DEVIATION REQUEST AND DECISION FORM

Project Name :	Mayberry Phase 1 PUD Amendment
Schedule No.(s) :	3414201030
Legal Description :	See attached plan sheet

A deviation from the standards of or in **Section F SD_2-77 "Urban Knuckle"** of the Engineering Criteria Manual (ECM) is requested. Please refer to the Deviation Exhibit Nos. 1a, 1b, 2 and 3. The specific locations are shown in Deviation Exhibits 1a and 1b.

Deviation Exhibit 2:

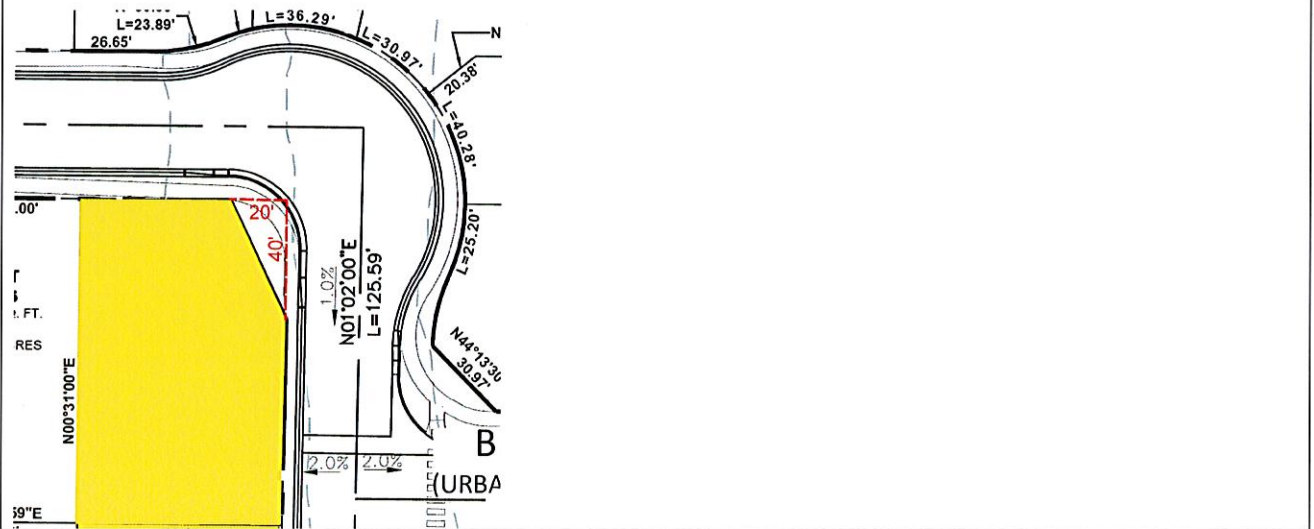
The proposed alternative, shown in the attached Deviation Exhibit 2 (below), would modify the length of the standard sight-distance-triangle leg from 40' and 20' along the street leg (extending back from the knuckle) onto which the corner lot will have driveway access. This is shown for several locations, which are shown in the attached Deviation Exhibits 1a and 1b. A copy of the ECM Urban Local Knuckle standard plan sheet (SD_2_77) is also attached for reference. The standard plan sheet shows several standard dimensions, including the inside radii and the sight-distance triangle (SDT) dimensions.

This request has been determined to have met the criteria for approval. A deviation from Section F, SD 2-77 of the ECM is hereby granted based on the justification provided.

Deviation Exhibit 3

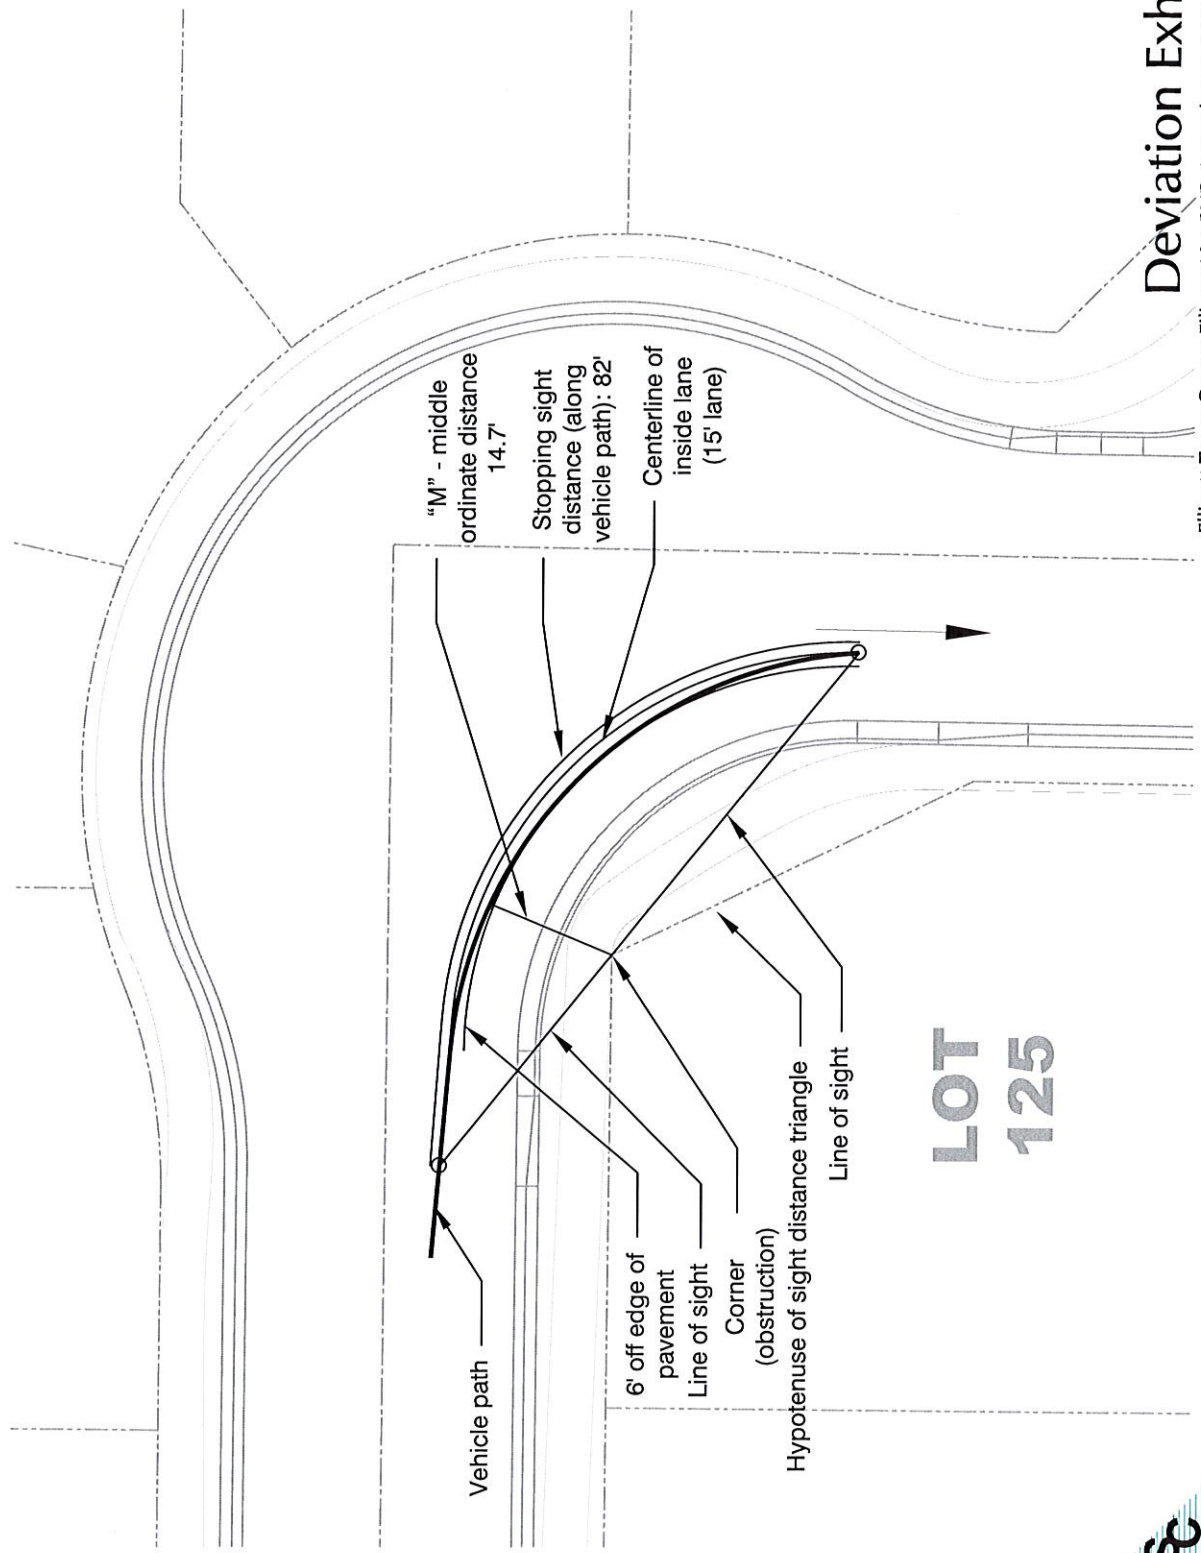
The inside edge of pavement radius is 37 feet (the same as SD_2_77) and the centerline radius through this 90-degree curve/knuckle is 52 feet. Please refer to the attached Deviation Exhibit 3. Assuming a design speed of 15 mph around the curve of this knuckle, the required stopping sight distance is 80 feet. Based on Figure 2-21 in the ECM, the required "M," middle ordinate distance, centerline of inside lane to obstruction is 14.6 feet. Exhibit 3 shows the M value for the proposed sight-distance-triangle leg lengths. The measured M is 14.7. Therefore, the Stopping Sight Distance, 82 feet, on Horizontal Curve 2.3.6.C would be met.
